T10/08-267 Revision 0

Date: July 1, 2008

Subject: SAS-2 Domain Management Zoning Interaction

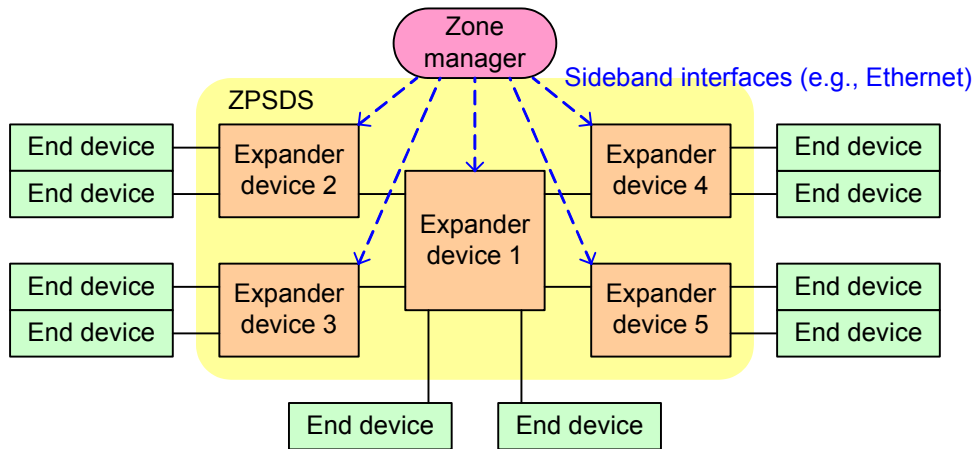
SAS 2.0 currently has overloaded Zone Group 2 access for 2 of these roles:

- 1) Access to Zone Management SMP functions (ie. ZONE LOCK, CONFIGURE ZONE PHY INFORMATION)
- 2) Access to Domain Management functions (ie. PHY CONTROL, PHY TEST, CONFIGURE PHY EVENT), however the REPORT SMP functions are missing.

This proposal however seeks to split this functionality into these 2 roles, thereby allowing one management server to be the ZONE MANAGER, and another management server be the DOMAIN MANAGER. An example usage of this would be one of the following example topologies (Figure 50 from SAS2r14c), where the Zone Manager is a side-band interface to the expanders, and the Domain Manager is running on one of the Initiator End Devices.
